Report to the Future Melbourne Committee

Serial Planning Referral: ID-2021-3
13-33 Hartley Street, Docklands

15 February 2022

MINISTERIAL PLANNING REFERRAL DELEGATE REPORT

Figure 25 – Proposed north podium elevation

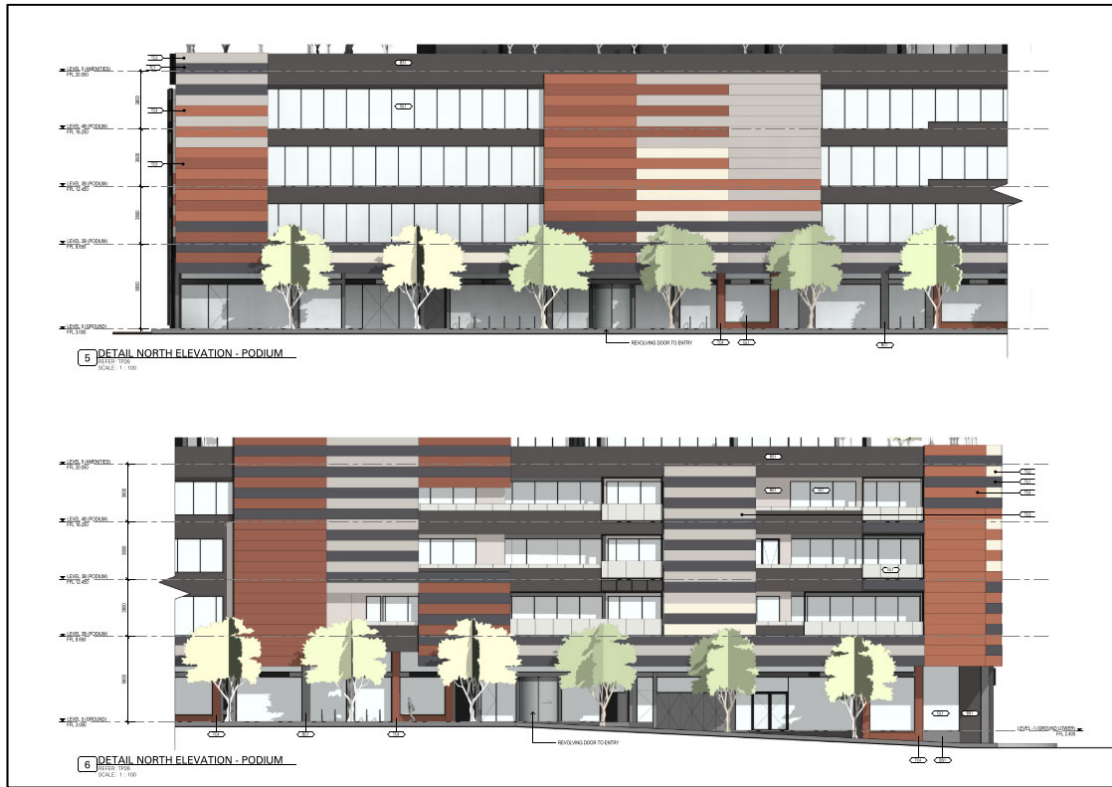
Ground plane design includes the use of ‘terracade’ and concrete, including the services cabinets. While we support the use of the terracade, we question the blanket application of this material across multiple varied elements of the podium facade, including the ground plane. The ground level elevations could benefit from being visually distinct, with a higher level of human-scale, nuance and detail. This should be achieved through the integration of shrouds, plinths and pilasters, with a consideration

of more textured and robust materials. This was a successfully achieved though the previous design; however, a level of fine-grain detail has been lost with the design updates (Figure 31 and 32).

Figure 33 – Podium façade design to the new road and Hartley Street

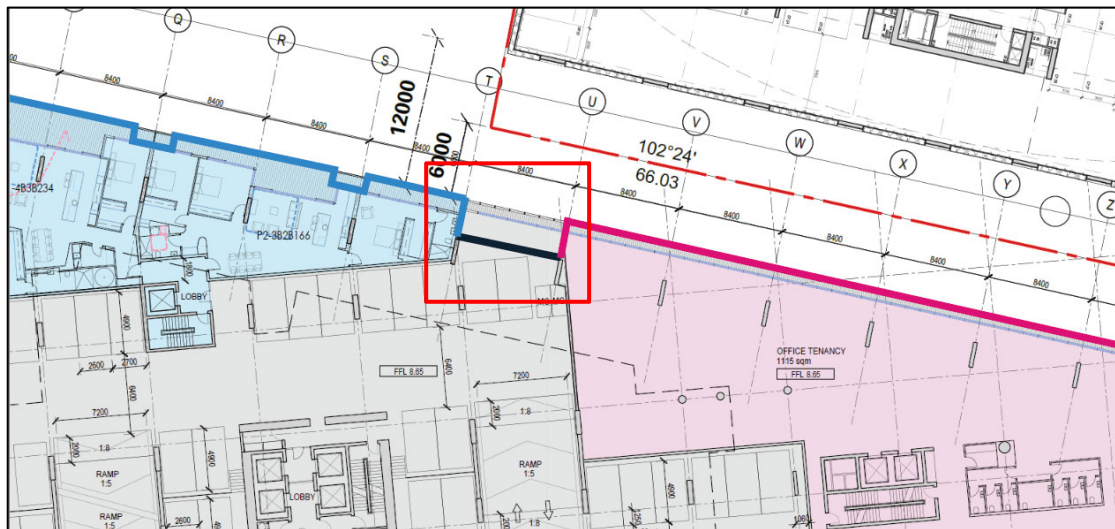
- *Provide vertical breaks in the façade. This could be established through reinstating the separated balconies, and through recesses in mass. We identify an opportunity for a substantial recess associated with the podium car parking interfacing at the north elevation (Figure 33 and 34);*

- *Besides the ‘terracade baguettes’, the primary material used to the podium façade is BS1 – ‘concrete spandrel’, which occurs across podium façade and ground plane. Considering its extensive application, this material should be highly robust, and have a natural pigment. A texture could be considered to add further variation and dynamism to the podium and ground plane expression to the street. The balance between the concrete spandrels and terracade baguettes is a crucial*

part of achieving the design quality of the proposal, so this material should be accurately specified with additional detail.

Figure 36 – Map 4 from DDO67

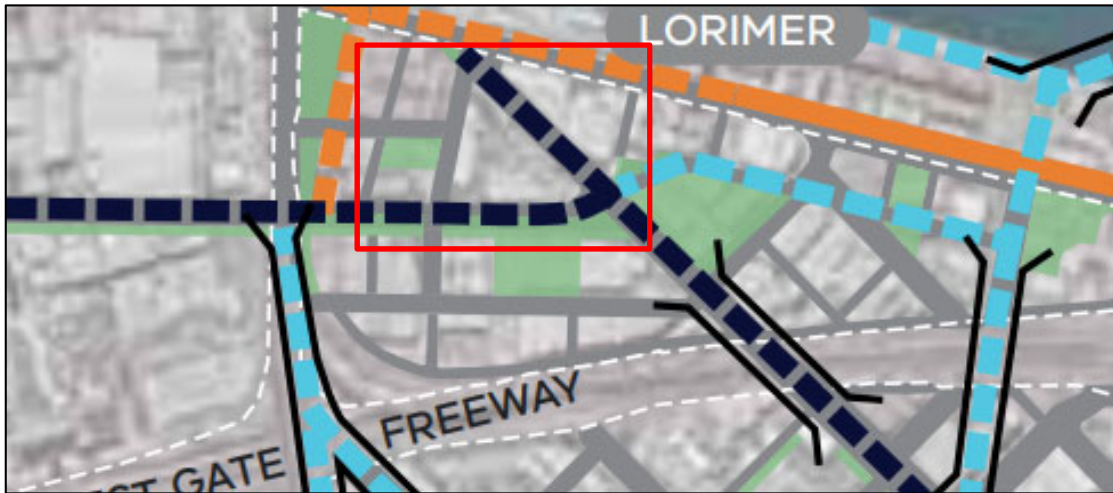
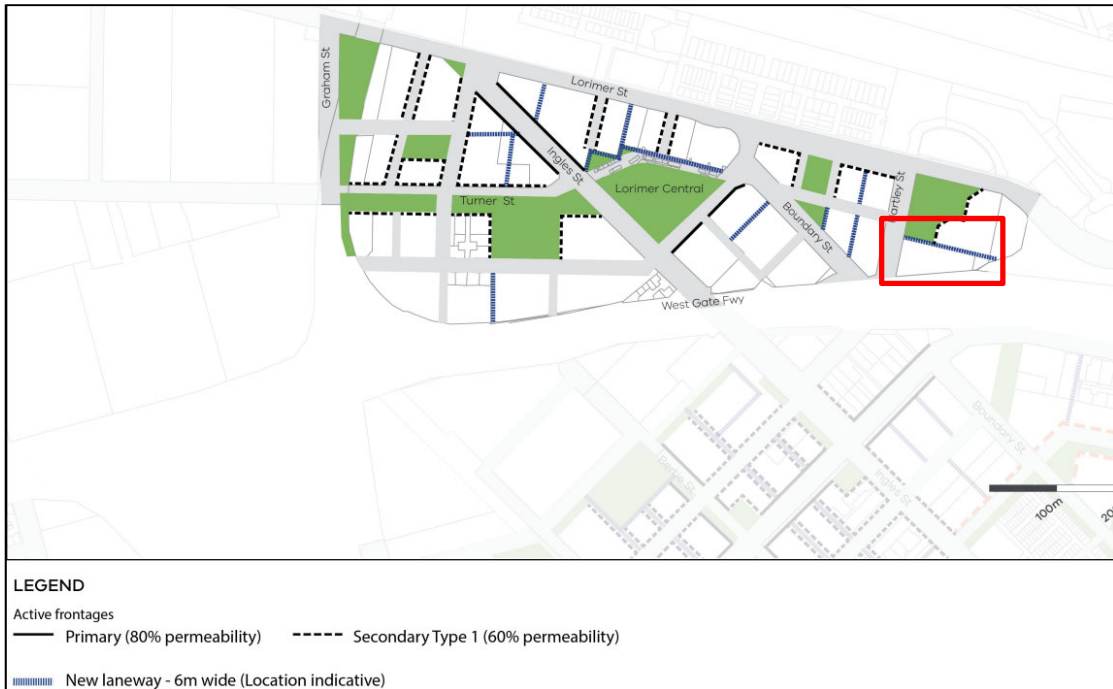
While it is understood there is a different location for the road in the Fishermans Bend Framework 2018 (Figure 35), DDO67 contains a different road / lane arrangement which the proposal seeks to comply with (Figure 36).

Figure 41 – Shadow diagrams

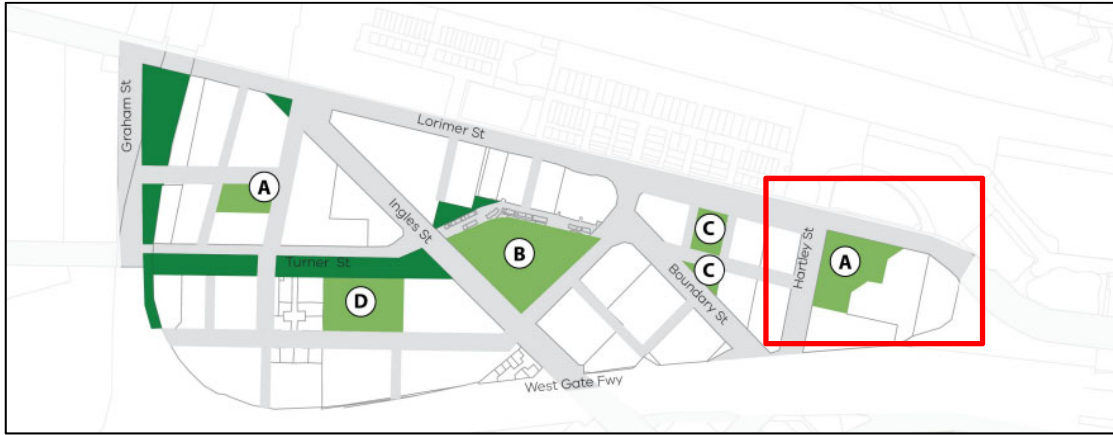
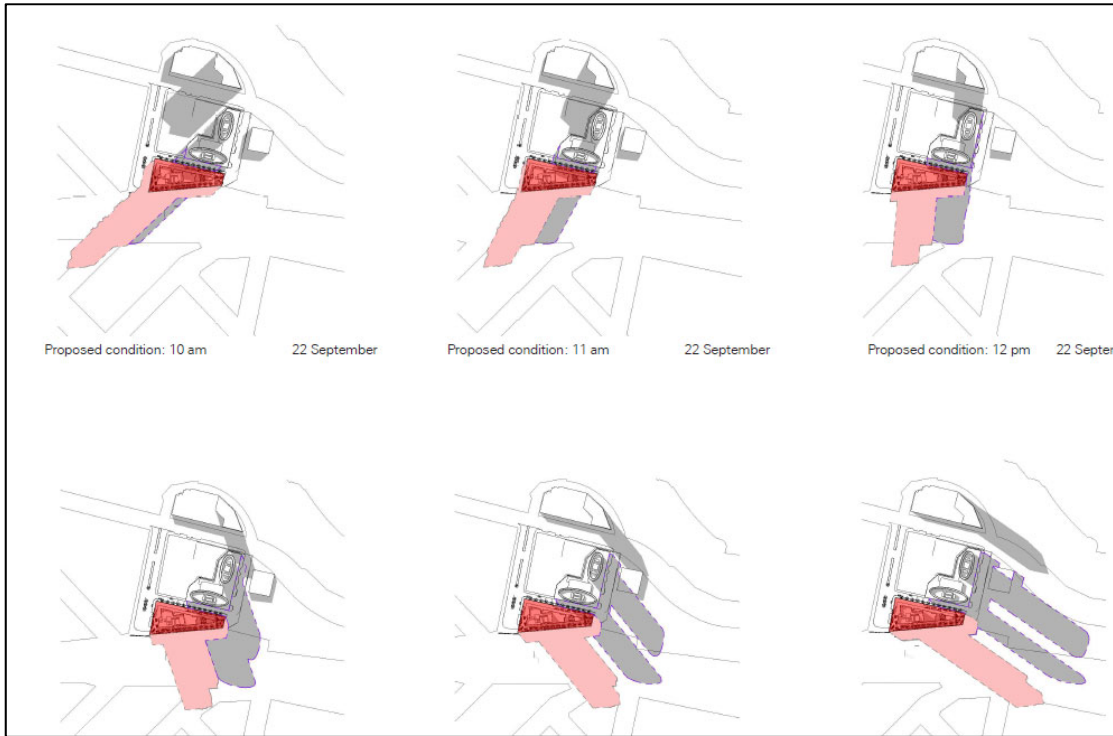
This includes the extent to which it would overshadow the proposed future public open space to the north which is nominated as a future park – refer area ‘A’ in Figure 40 and the shadow diagrams at Figure 41.

Figure 42 – Affected properties

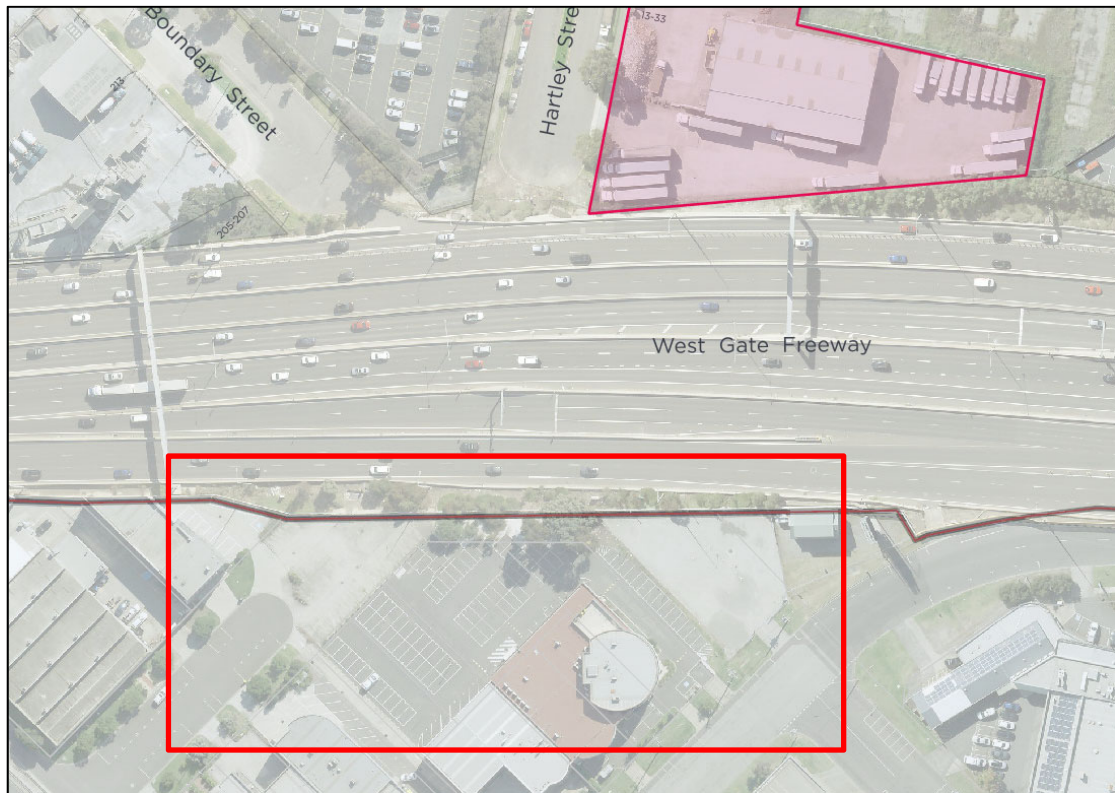
The proposal also avoids unreasonable shadow impacts to public and private property, noting the shadows cast throughout the day fall on roads south of the West Gate Freeway as commercial properties (Figure 41 and 42). Where the southern commercial properties are affected, most impacts apply to a car park (Figure 42).
